NUCLEAR ENERGY INSTITUTE

SUBJECT: Generic Aging Lessons Learned Report Comments

PROJECT NUMBER: 690

# GALL REPORT-CIVIL/STRUCTURAL COMMENTS Section IIA1

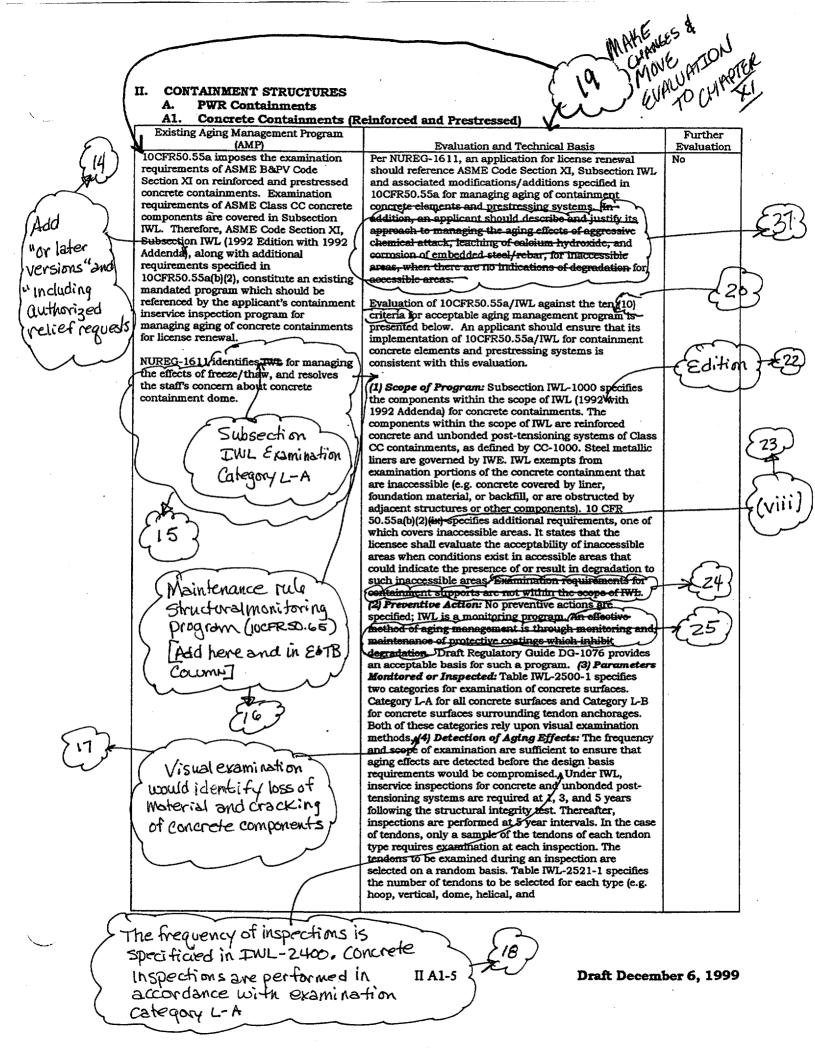
Containment HVAC (VII.F3) Containment Isolation System (V.C) Containment Spray (ViA) Containment Heat Removal Main Steam System (VIII. BI) Feedwater System (VIII.DI) POLAr (rane (VII. B2)

Revise references to match Table of Contents
